RE: Lincoln Drive Median Access from Mockingbird Lane to the Eastern Town Limits

MEMORANDUM

Subject: Lincoln Drive, Mockingbird Lane to Town of Paradise Valley (TOPV) Jurisdiction
Median Breaks and Access
Third Party Traffic Review Comments

Resort Hotel (330)

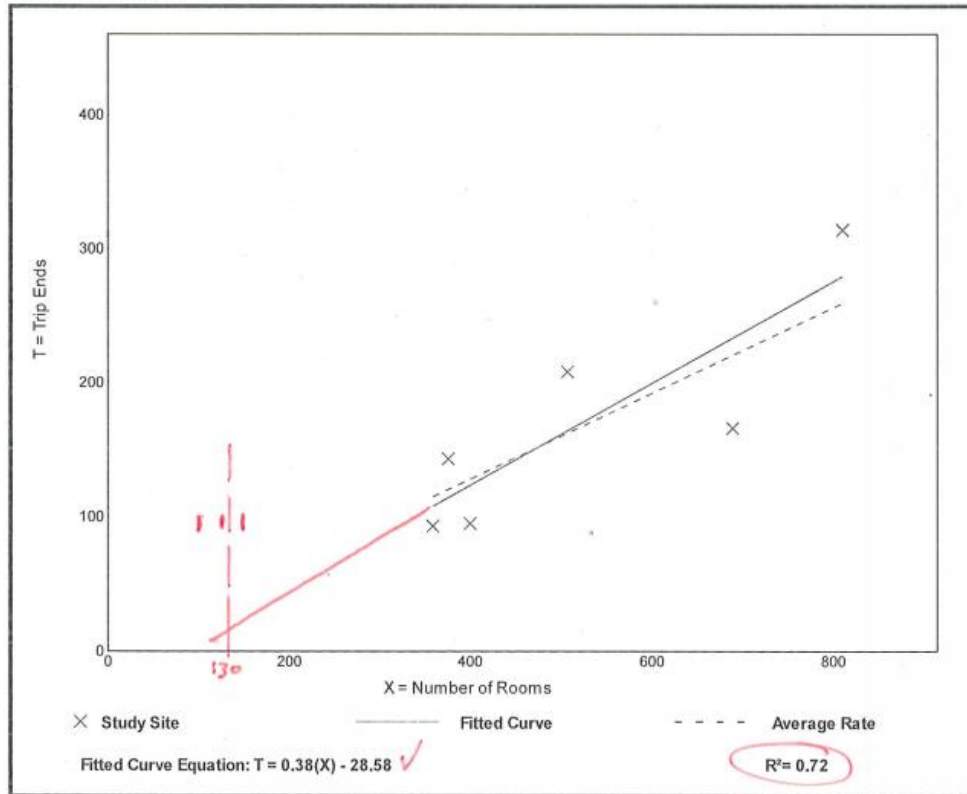
KH Comments 4: Smoke Tree Resort utilized equations as opposed to average rates. KHA went through the ITE Trip Generation Handbook process presented in Figure 4.2 assuming proposed number of units for resort hotel (LUC 330). The results of this process are presented below and KH redlines provided in **Appendix 1**.

- The number of rooms is way out of range of the data extremes; the lowest number of rooms in the manual is roughly 370 compared to the 132 that are proposed
- If you follow the equation, which happens to be a straight line and not a logarithmic function, then 132 rooms will generate a very low number of trips
- The number of data points is equal to 6
- The R2 value is close to the required 0.75, so you could argue it either way
- The standard deviation is less than 55% of the average rate

Because the rooms are not within the data extremes and the R2 value is less than 0.75, we recommend the weighted rates be used. Using the rates as opposed to the equation results in double the trips being generated in the AM peak hour.

Response to Comment 4: CivTech has updated the trip generation rates to reflect a blended rate between LUC 310 and 330 as discussed in response to comment #3. The trip generation calculations were also revised to reflect 150 rooms, 30 residential units, and 3500 square foot quality restaurant. The revised trip generation calculations and approach were considered acceptable. The revised trip generation calculations, based on 150 rooms, 30 residential units, and 3500 square foot quality restaurant, are provided in **Appendix 2**.

Resort Hotel (330)

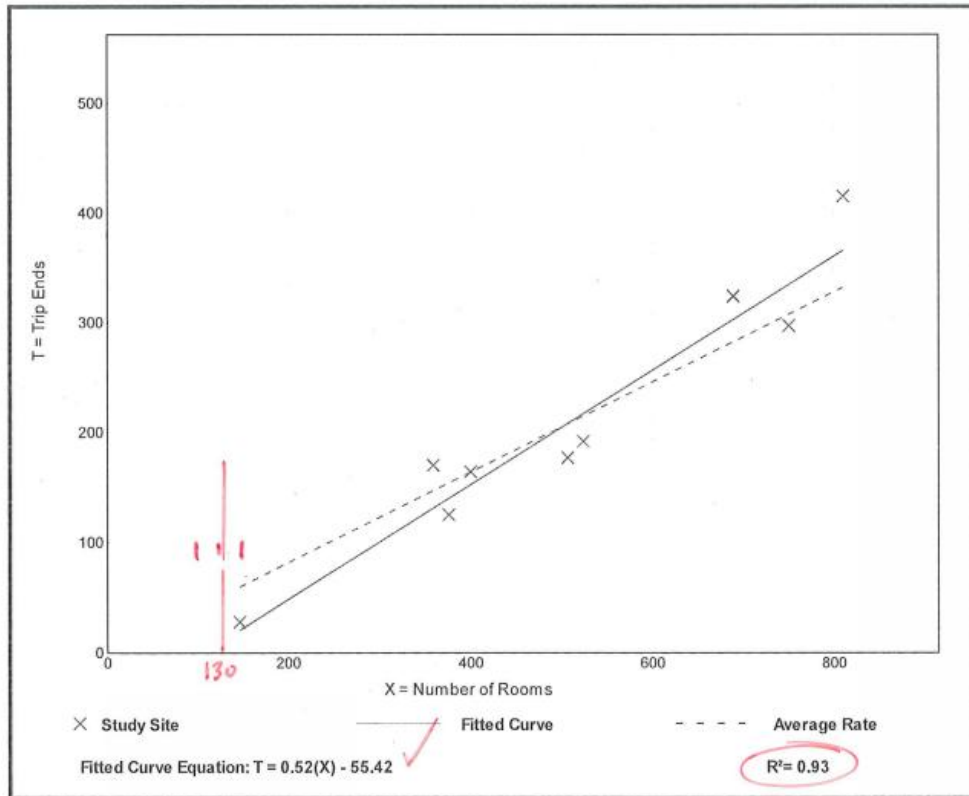
- The number of rooms is just outside of the data extremes
- The number of data points is greater than 6
- The R2 value is well above the required 0.75
- The standard deviation is less than 55% of the average rate

Because the number of data points and the R2 value are high enough and the standard deviation requirement is met, the use of the equation during the PM peak is appropriate.

SHEET
Opt-01
01 OF 03

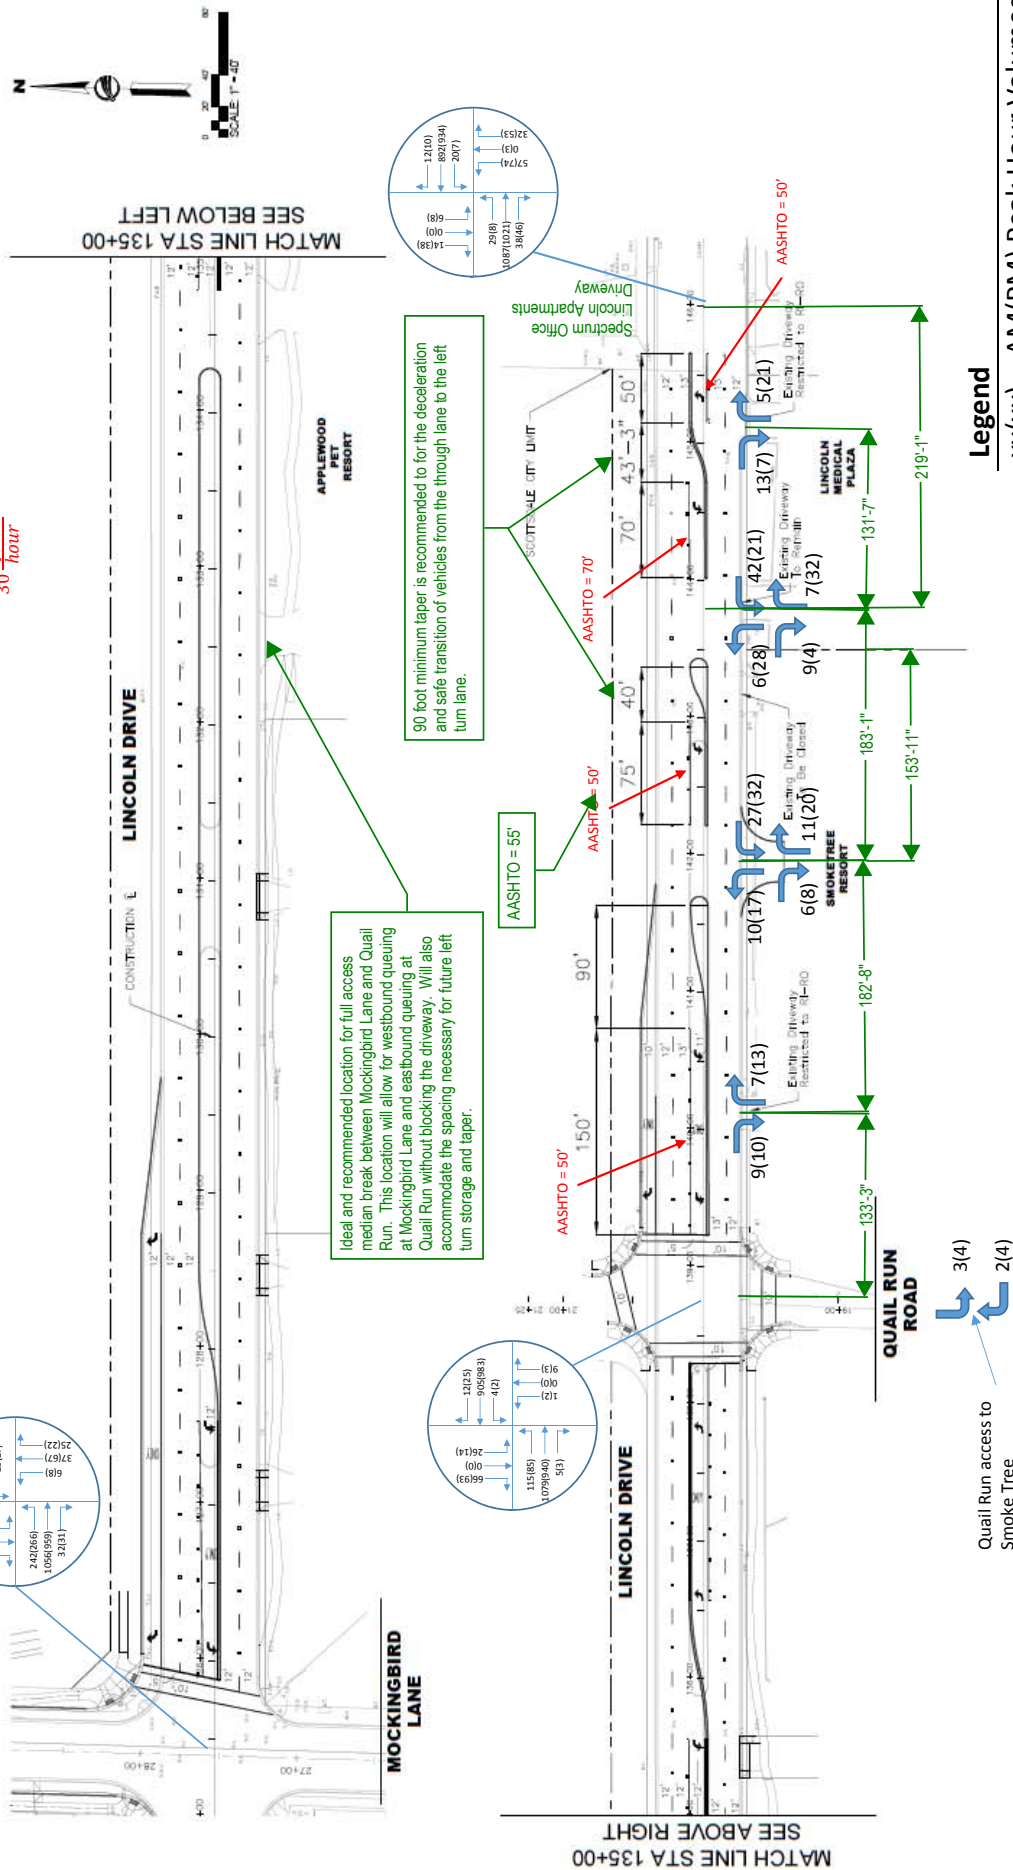
KH Comment 10: Storage length at Spectrum Office Driveway/AJ Driveway calculation ((29 vph x 25 feet x 2)/30) is 48 feet. Per AASHTO, the minimum storage length is 50 feet. Exhibit illustrates a minimum of 50 foot being provided. This is considered acceptable.

KH Comment 11: As shown in Option #1 exhibit, access improvements include closure of the existing eastern access on Smoke Tree Resort, a new Smoke Tree Resort access approximately 183 feet west of Lincoln Medical Plaza access, and the existing Smoke Tree Resort western access to remain as right in/right out. The proposed improvements result in the following spacing (centerline to centerline) of driveways:

- Approximately 134 feet from Quail Run to Smoke Tree Resort western right in/right out driveway;
- Approximately 183-feet from Smoke Tree Resort western right in/right out to the proposed Smoke Tree Resort full access median break;
- Approximately 183-feet from the proposed Smoke Tree Resort full access median break to the proposed Lincoln Medical Plaza full access median break; and
- Approximately 132 feet from the proposed Lincoln Medical Plaza full access median break to the eastern Lincoln Medical Plaza right in/right out access.

Based on the results, Kimley-Horn recommends the western Smoke Tree Resort driveway be closed to achieve the minimum spacing from Quail Run.

KH Comment 12: The storage length shown in Option #1 exhibit for Lincoln Medical Plaza is 70 feet. Per AASHTO calculations, storage length should be no less than 70 feet to adequately store the estimated number of vehicles generated by Lincoln Medical Plaza. This is considered acceptable. The storage length for the Smoke Tree Resort eastern driveway is 75 feet. Per AASHTO calculations, storage length should be no less than 55 feet to adequately store the estimated number of vehicles generated by the Smoke Tree Resort. This is considered acceptable.

KH Comment 13: As shown in Option 1 exhibit prepared by CivTech, opening bay tapers are 40 feet at Smoke Tree Resort and 43-3” feet at Lincoln Medical Plaza. KH recommends that no less than a 90-foot opening taper be utilized to safely traverse traffic from the through lane to the left turn lane on Lincoln Drive, per the criteria and discussion on Page 4, 5, and 6 of this document. Kimley-Horn recommends the median be extended and access points to Lincoln Medical Plaza be restricted to right in/right out only movements for two reasons:
